CABINET MEMBER FOR ENVIRONMENT – 12 JULY 2018

OXFORD – GEORGE STREET/HYTHE BRIDGE STREET/WORCESTER STREET JUNCTION – PROPOSED AMENDED JUNCTION LAYOUT AND PEDESTRIAN & CYCLE PROVISION

Report by Director for Planning & Place

Drawing title
George St / Hythe Bridge St / Worcester St Junction, Oxford
Consultation Drawing

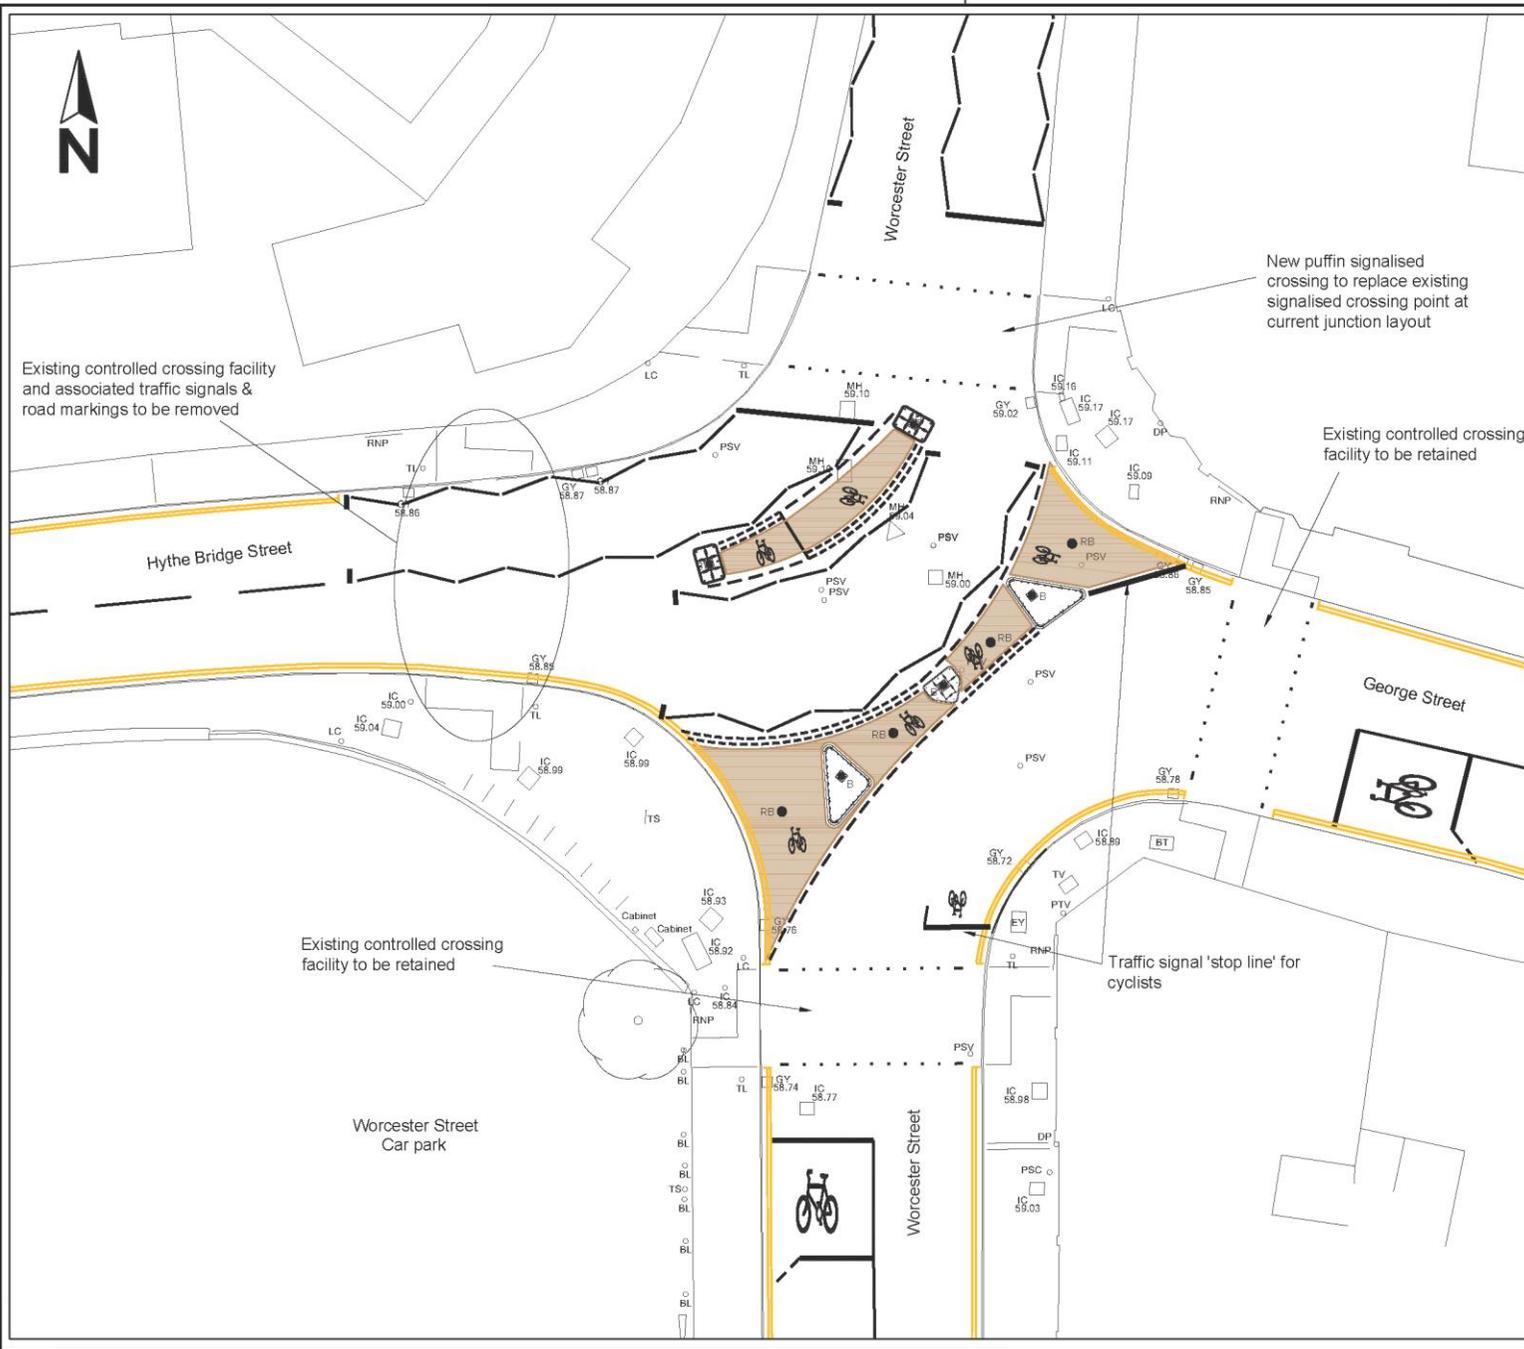
RESPONDENT	SUMMARISED COMMENTS	OFFICER COMMENTS
(1) Traffic Management Officer, (Thames Valley Police)	<p>Object - I can find no provision within the Traffic Signs Regulations and General Directions that allow for these road markings within the controlled area of a pedestrian crossing.</p> <p>I suspect with the new Puffin crossing positioned where it is there might also be serious visibility problems associated with the signal heads for northbound traffic flow.</p> <p>Based on these points I object.</p>	<p>The detailed scheme design will be carefully reviewed in the light of these and other comments received to allow further improvements before progressing to implementation of changes.</p> <p>This process will take into account any safety concerns about visibility raised as part of the Road Safety Audit process</p>

(2) Cllr Pressel, (City & County Cllr for Jericho and Osney)	<p>Support - I think this is a long -overdue improvement, but I have one more question, please. Is it possible to have advanced stop lines for cyclists in both directions at the new puffin crossing? I think this would be safer and help to encourage more people to cycle.</p> <p>I hope that the scheme can be implemented very quickly, once agreed</p>	<p>The detailed scheme design will be carefully reviewed In the light of these and other comments received to allow further improvements before progressing to implementation of changes.</p> <p>Advanced stop lines at a Puffin crossing require special authorisation by DfT. As part of a review of the detailed design, officers will investigate the possibility of including ASLs that would receive such authorisation.</p>

<p>(6) Oxfordshire Transport & Access Group</p>	<p>Object - Likely problems:</p> <ol style="list-style-type: none"> 1. Some pedestrians will walk diagonally between the SW and NE corners and come into conflict with cyclists. 2. Some cyclists will not follow the routes designated for them through the SW-NE separation; they will take the shortest possible route when they see a gap in opposing traffic. 3. Cyclists might not expect the unusual arrangement of traffic signal stop lines for cyclists, and might fail to comply with them. This would be particularly dangerous for disabled pedestrians and wheelchair-users. 4. It would no longer be possible for buses to use Hythe Bridge St and Park End St to turn around. <p>My suggested alternative: Simply banning the right turn from George St into Worcester St north, and removing all the pedestrian crossings except the Worcester St north crossing (the most heavily used) would allow traffic from George St to proceed at the same time as pedestrians crossed Worcester St north. In the existing layout, pedestrians tend not to wait for green to cross Worcester St south and George St.</p> <p>Whichever layout is taken forward, advance stop lines for cyclists will improve safety and convenience for cyclists, particularly on the Hythe Bridge St arm of the junction where cyclists need to access the area provided for them to wait safely before turning into Worcester St south or George St.</p>	<p>The detailed scheme design will be carefully reviewed in the light of these and other comments received to allow further improvements before progressing to implementation of changes.</p> <p>This process will take into account any safety concerns including any potential concerns for pedestrians and cyclists safety in the light of the proposed arrangements for the junction as part of the Road Safety Audit process</p> <p>The loss of this element of flexibility for bus routing needs to be considered in the wider context of significant benefits to the flow of buses on the routes that will still be allowed.</p> <p>Advanced stop lines at a Puffin crossing require special authorisation by DfT. As part of a review of the detailed design, officers will investigate the possibility of including ASLs that would receive such authorisation.</p>

<p>(9) Cyclox & Cycling UK, Oxford City</p>	<p>Object</p> <p>We note (from consultation page on website) that the current design comes under Section 1 (1) (a) Road Traffic Regulation Act 1984 "for avoiding danger to persons or other traffic using the road or any other road or for preventing the likelihood of any such danger arising". While the previous design failed to meet the afore-mentioned section, this design at least makes some attempt to comply.</p> <p>The layout looks similar to the one that was there before the change in 2014 that created the teardrop junction (a moniker we fear will remain even after these revised plans are executed) which was the source of many collisions with bikes. It was also a major source of complaints.</p> <p>We welcome return to the separation of traffic flow between Hythe Bridge Street to Worcester Street north, and George Street to Worcester Street south, with bollards to prevent motor vehicles crossing between those two flows but allowing access by cycle. We are pleased that you are clearly recognising the importance of accommodating safe cycling at this junction. The concepts are sound, but there is not enough highway space at this junction to make it safe. We think that the zigzag lines will act to emphasise the presence of the #lethalteardrop</p> <p>However we object to this plan on the following grounds:</p> <ol style="list-style-type: none"> 1. Cyclists crossing from Hythe Bridge Street to George Street <p>Cyclists going from Hythe Bridge Street to George Street may be going 'straight on' but in effect they are taking the equivalent of a right turn because of the need to cross a line of traffic. A right turn across traffic is the most dangerous and intimidating manoeuvre for a cyclist in traffic and the fullest possible protection is needed.</p> <p>This has been the most dangerous manoeuvre on the junction. The proposed layout does not improve the situation. It remains difficult for cyclists coming east along Hythe Bridge Street, and wanting to go on to George St, or south along Worcester St South, to gain access</p>

<p>across the traffic lane to the refuge.</p> <p>We are very concerned to see that there is no pedestrian crossing on the west side of the junction. At present while there fewer pedestrians crossing the road using the existing pelican crossing than on the north side pedestrian crossing nevertheless, on a visit we made to the junction, it was well used.</p> <p>By keeping a pedestrian crossing at the west side of the junction, and synchronising it with the one on the north side, this will provide a space for cyclists to move across to the island once the lights change.</p> <p>In one of our submissions during consultation on this junction we suggested that an advance stop square before the puffin crossing across Worcester Street North which will give cyclists the opportunity to get ahead of cars and across to the isthmus. We still think that would be the best option.</p> <p>We suggested when we were consulted in person, that the pedestrian crossing on Worcester St North should be activated by an induction loop detecting cycles in the island box (Hythe Bridge -> George Street), so that they don't depend on a pedestrian to call for the green, while cycles wait for a clear route into George St. Alternatively a pedestal mounted push button on the island should be provided so that cyclists can activate the lights themselves. Please confirm that this can be done.</p> <p>For the HBS > George St cycle entry into George St, the cycle stop line needs replacing with a give way, and the stop line moved up to the traffic lights. The proposed stop line is too far from the pedestrian crossing to seem related to the pedestrian lights, so risking cyclists riding through the pedestrian crossing on green pedestrian. Further, the cycle stop line should be at right angles to the (imaginary) center line (or kerb)? See 9.4 mentioned below.</p> <p>If you don't wish to consider the option of synchronised lights on the west and north then we suggest the stop line at the pedestrian crossing is drawn perpendicular to the kerb (and further back from the lights if possible). This might create enough space for cycles to move across ahead of the stationary vehicles at the stop line. (Technically</p>	<p>The detailed scheme design will be carefully reviewed in the light of all of these comments to allow further improvements before progressing to implementation of changes.</p> <p>This process will take into account any safety concerns raised as part of the Road Safety Audit process.</p> <p>Any changes to the design will be discussed with Cyclox to ensure that as much as possible the concerns are addressed.</p>

<p>this invites cyclists to cross the stop line, but adheres to the spirit of the lights (doesn't invite you to cycle through the crossing on red)).</p> <p>STOP LINES</p> <p>DfT guidance says that the Stop line should be positioned a minimum of 1.5m in advance of the near side primary signal, although 2.5m should be used where practicable. The marking should be positioned at right angles to the centre line of the carriageway, even at skew junctions.</p> <p>2. Width of waiting areas There is the potential for conflict between South-North and East -West cycles in the island (the 2 routes waiting areas only separated by a white line, East > West cycles likely to cut across the north end of the (not very deep) South -> North waiting area. Waiting cycles can't see any traffic lights to know when it is actually safe to go.</p> <p>The alignment of the East->West cyclerooute (George -> Hythe Bridge) should be altered to be straight, not kinked. Please confirm that this change has been made.</p> <p>The width of the both the waiting area for the refuge and the isthmus look like they won't fit a cargo bike/bike + tag along etc. We are of the view that the waiting area is not safe/fit for purpose.</p> <p>The effectiveness of all waiting areas is significantly reduced by the use of buff rather than green finish (which everyone recognises and mostly respects).</p> <p>3. The island and bollards There are six bollards on the Isthmus waiting areas which will constrain capacity, and limit the availability of space for cargo bikes. It would be useful to know what the distance is between each bollard. The "isthmus" bollards are removable - is this for St Giles Fair traffic arrangements, if so are the gaps adequate for vehicles to pass?</p> <p>The island can be run over by vehicles unless there are significant bollards, so what real protection do these offer? The yellow sign on the existing island has been driven over a few times, so obviously</p>

<p>offers no physical impediment currently. We attach a photo which shows the damage on the existing bollard on the island.</p> <p>These are as far as we can tell bolt down rubber kerbed islands. These will offer zero resistance to vehicle wheel over run. For meaningful cyclist protection, these islands need substantial kerbs.</p> <p>4. Paths of buses Thanks for providing us with the swept path analysis. The analysis shows 15m coaches using the whole road kerb to kerb. We are very concerned that the swept paths give no leeway for any error in judgement by drivers, potentially running over pavements and central bollards, not to mention potentially colliding with cyclists and pedestrians. We realise that the space just does not allow for anything more but we request that you consider educating bus drivers or even banning 15m buses from using the Hythe Bridge St/ Worcester St North. We are also concerned that 15m coaches need to turn on full steering lock, further limiting the leeway for error.</p>
